PROJECT NAME  
1675 PIEDMONT  
SUBDIVISION

**PETITION NO:** Z-56

**PLANNING COMMENTS:**

## STAFF RECOMMENDATIONS

# Z-56

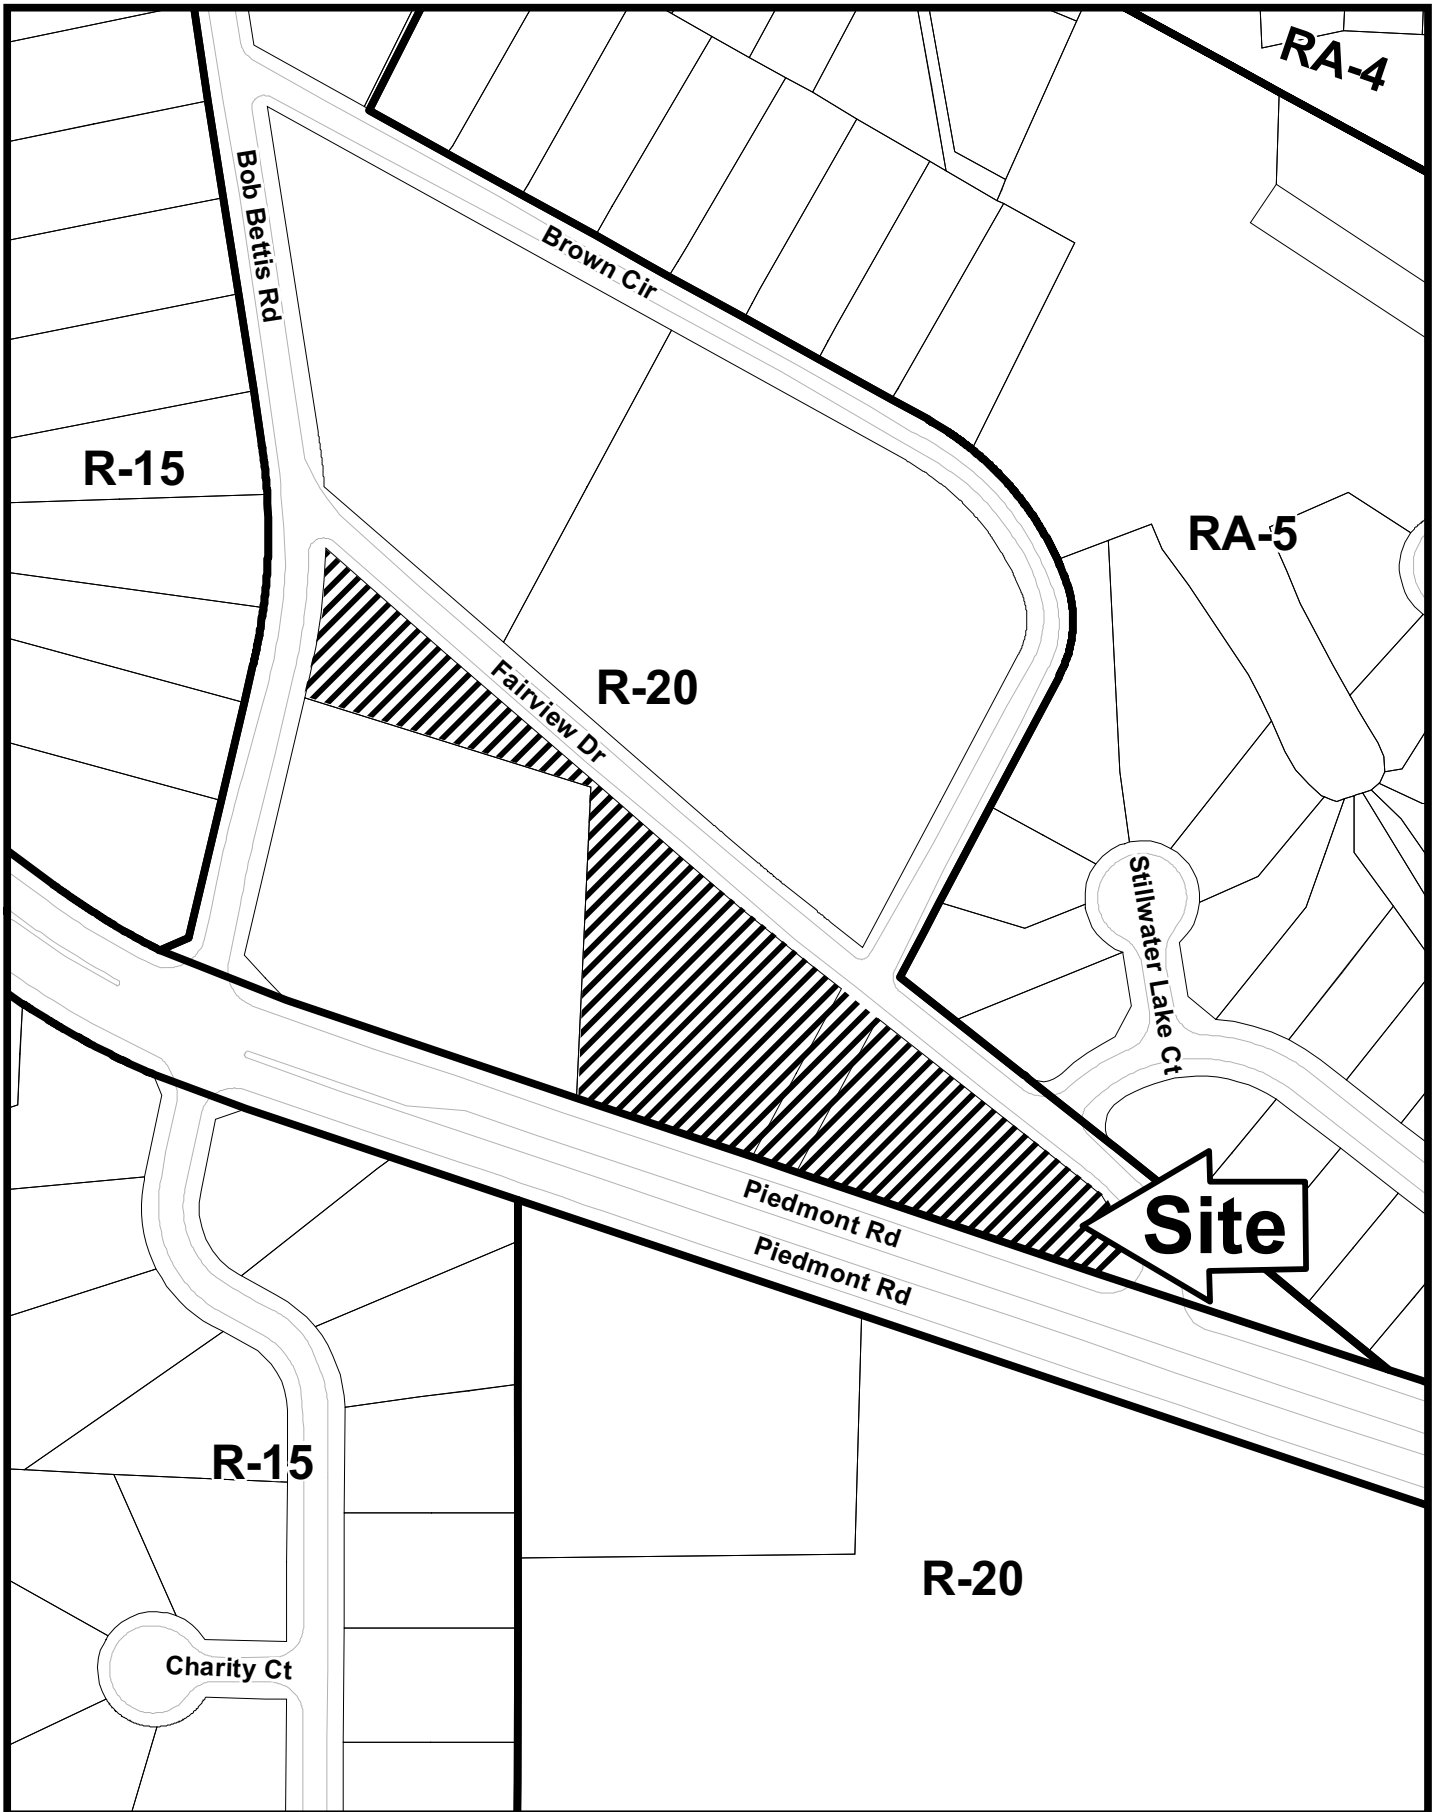
Applicants for Z-56 and Z-58 have submitted a site plan combining the tracts they each had submitted separately. The combined site plan indicates the houses on lots 12 and 13 will be accessed by a 20-foot driveway easement from Fairview Drive. Each lot is over the required 7,000 square-foot minimum lot size for the RA-5 zoning category. Applicants have indicated that the houses will range in price from the \$200,000s to the \$400,000s. Applicant for Z-56 indicated a mixture of siding to include shake, stone and brick. Applicant for Z-58 indicated the houses will be traditional. The site plan originally submitted for Z-56 indicated six lots on an approximate 2.2-acre section of the overall properties, having a density of 2.7 units per acre. The original site plan for Z-58 indicated five lots on a cul-de-sac coming off Bob Bettis Road, being a tract of 1.6 acres having a density of 3.125.

- No Stormwater controls shown \_\_\_\_\_
- Copy of survey is not current – Additional comments may be forthcoming when current site conditions are exposed.
- No site improvements showing on exhibit.

1. This site is located just north of Piedmont Road in the triangle between Fairview Road and Bob Bettis Road. This parcel is contiguous with another zoning case, Z-58. Since these parcels are contiguous and drain to the same discharge point, it is recommended that stormwater management be handled jointly and the developments possibly combined to provide a more efficient layout. The revised plan received 8/15/13 provides for a combined layout. The proposed 20-foot driveway easement will likely need to include a drainage easement as well to provide adequate conveyance of stormwater runoff from lots 4-7 to the proposed detention pond.

Fairview Drive is classified as a local and according to the available information the existing right-of-way does not meet the minimum requirements for this classification.

Recommend applicant consider entering into a development agreement pursuant of O.C.G.A. 36-71-13 for dedication of the following system improvements to mitigate traffic concerns: a) donation of right-of-way on the south side of Fairview Drive, a minimum of 25' from the roadway centerline.

Recommend no access easement along the Piedmont Road frontage.

Recommend applicant verify that ROW existed and was abandoned as listed on the site plan.

- Maximum density of 2.5 units per acre, with the District Commissioner approving the final site plan;
- Fire Department comments and recommendations;
- Water and Sewer comments and recommendations;
- Stormwater Management comments and recommendations;
- DOT comments and recommendations; and
- Owner/developer to enter into a Development Agreement pursuant to O.C.G.A. §36-71-13 for dedication of system improvements to mitigate traffic concerns.
